DEVIATION REVIEW AND DECISION FORM

Subdivision or Project Name: Saddlehorn Ranch Preliminary Plan

REDUCED RADIUS VARIANCE REQUEST

SADDLEHORN RANCH
REDUCED RADIUS VARIANCE REQUEST
25142.00
08/19/19
SHEET 1 OF 1

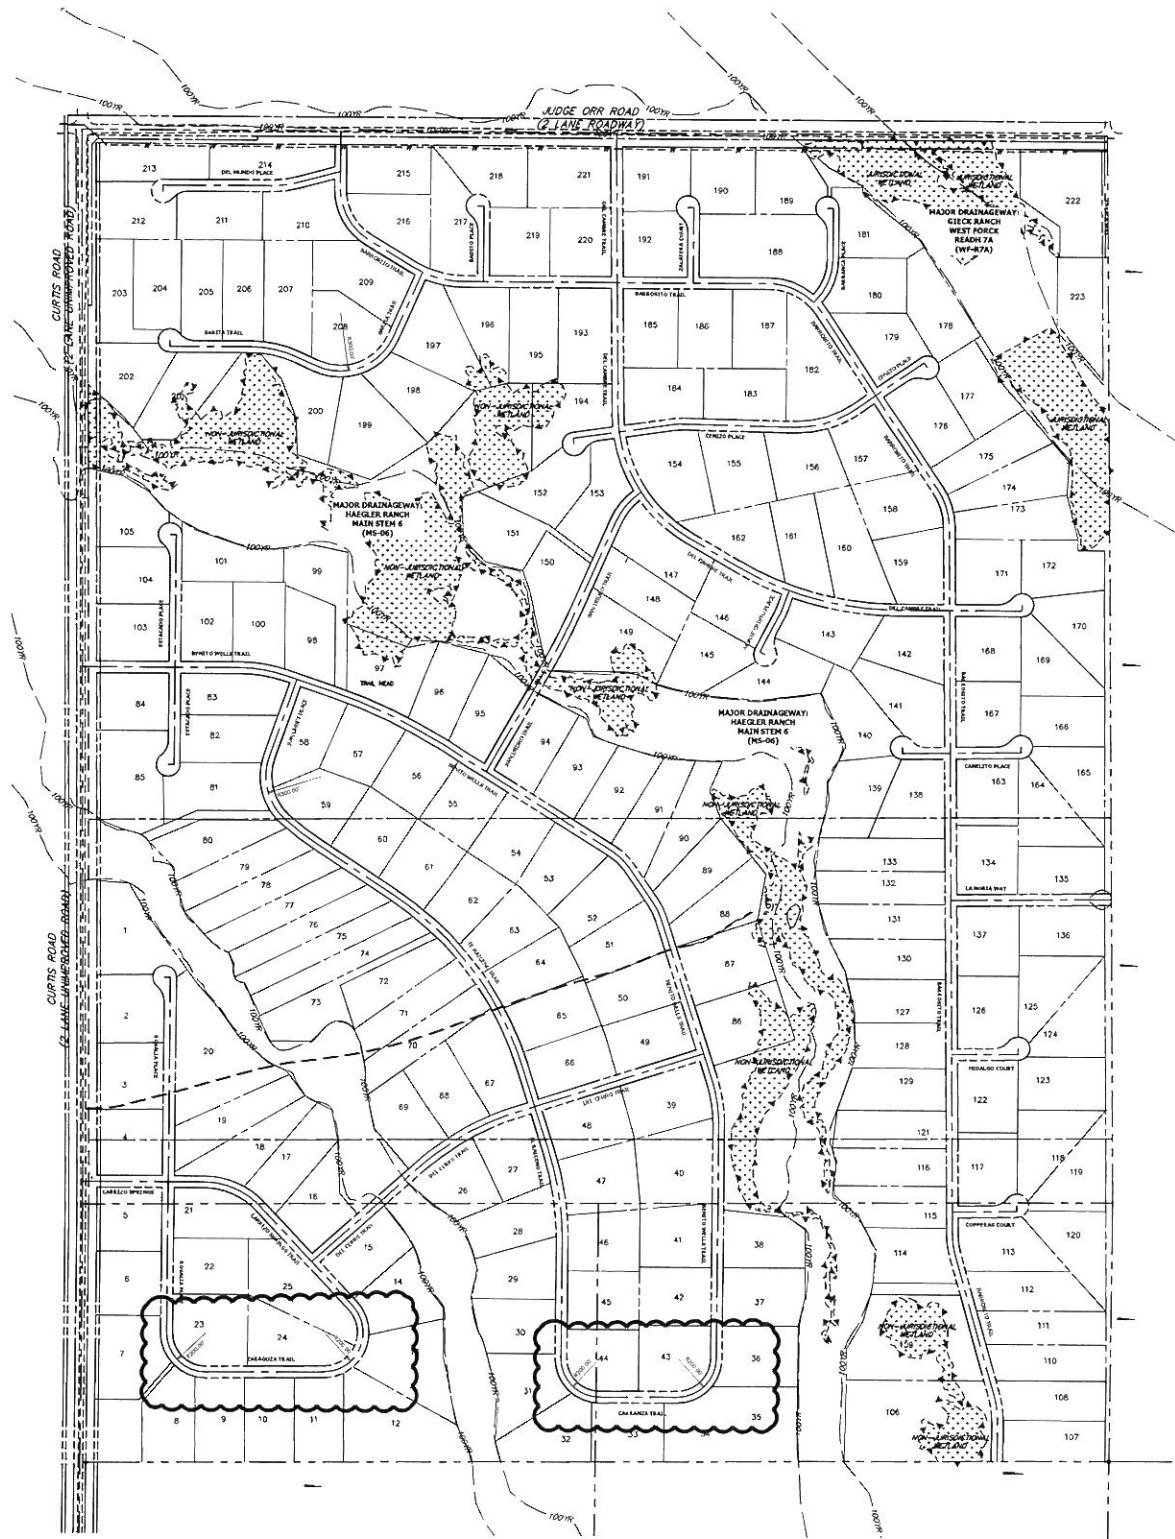
Proposed Nature and Extent of Deviation: Applicant wishes to use a 200 ft. radius at four locations shown on Attachment 1.

Proposed Nature and Extent of Deviation: Applicant wishes to use the urban local centerline radius in 4 locations within the property as opposed to the rural local centerline radius of 300 ft.
See Attachment 2 for ECM criteria for rural local centerline radius
See Attachment 3 for ECM criteria for urban local centerline radius for comparison

In the four locations where the deviation is requested, the natural features of the site (floodplain constraints and nearby Curtis Road) lends itself to the use of a "reduced radius" to create an efficient layout. Each area serves less than ten lots. Use of the required 300 ft. centerline radius would create the need for either excessively long flag lots or excessively large lots for the underlying R2.5 zoning

Use of standard radius curves would create excessively large lots in these specific areas or create the need for excessively long flag lots or create excessively large lots. If deviation granted applicant would reduce the posted speed from 30 mph (rural local) to 25 mph (urban local). The daily traffic volume on these streets is minimal, each location only serves 10 or less nearby lots.
